# Access Compliance Report

## Public Rights-of-Way

Intersection ID: 48432	Main Street: WHITHORN_WY	Cross Street: SEAMILL_RD	Location: SE
ADA ID: 57B07F859797	Ramp Type: PerpDiag	Initial Pass/Fail: Fail	Overall Compliance: No
Severity Score: 21.25			
Codes/Mitigation Info/Possible Solution		Field Measurements/Component Compliance

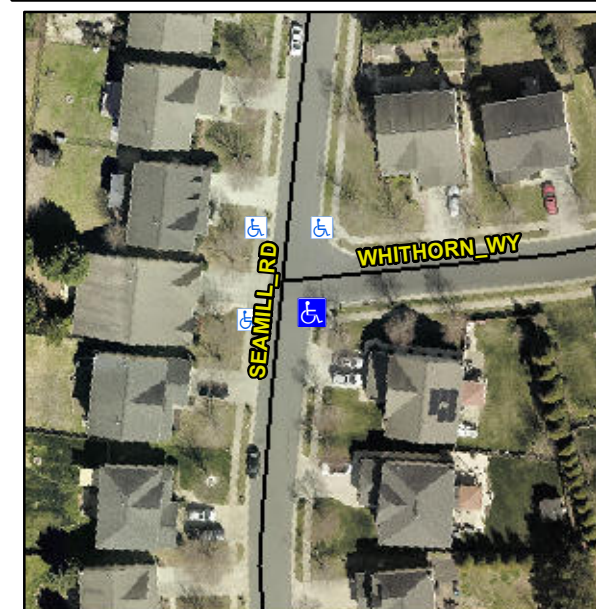
Compliance	Description	Data	Compliance	Description	Data
N/A	Ramp Length (in)	49.0	Yes	Ramp Slope (%)	6.3
No	Ramp Width (in)	44.0	No	Ramp XSlope (%)	5.7
N/A	Flare Type LT	N/A	N/A	Flare Type RT	N/A
N/A	Flare Slope LT (%)	N/A	N/A	Flare Slope RT (%)	N/A
N/A	Flare Traversable LT?	N/A	N/A	Flare Traversable RT?	N/A
N/A	Landing Length (in)	N/A	N/A	DWS Provided?	N/A
N/A	Landing Width (in)	N/A	N/A	DWS Contrast?	N/A
N/A	Landing Slope (%)	N/A	N/A	DWS Length (in)	N/A
N/A	Landing X Slope (%)	N/A	N/A	DWS Full Width?	N/A
N/A	Landing Curb? (Y/N)	N/A	N/A	DWS Offset (in)	N/A
N/A	Shared Landing?	N/A			
N/A	Gutter Ponding?	N/A	N/A	Gutter Slope (%)	N/A
N/A	Gutter Lip Ht (in)	N/A	N/A	Gutter X Slope (%)	N/A
N/A	Painted X Walk1?	No	N/A	Painted X Walk2?	No
	X Walk 1 Direction	To NE		X Walk 2 Direction	To NW
N/A	X Walk 1 Width (in)	N/A	N/A	X Walk 2 Width (in)	N/A
	X Walk 1 Slope (%)	3.8		X Walk 2 Slope (%)	1.5
	X Walk 1 X Slope (%)	0.2		X Walk 2 X Slope (%)	4.4

N/A	Ramp inside XWalk1?	N/A	N/A	Ramp inside XWalk2?	N/A
	Road Slope (%)	3.3	N/A	Clear Space?	N/A
	Road X Slope (%)	4.2	N/A	Clear Space to XWalk (in)	N/A
N/A	Any Obstructions?	N/A	N/A	Storm Grate/Utility Hazard?	N/A
	Obstruction Type			Storm Grate/Utility Type	
		N/A			N/A
		Yes		Surface Condition? (G/P)	Good

**Remove & Replace Curb Ramp With Two New Directional Ramps or Equivalent.**

**R304.5.1, R304.5.3**
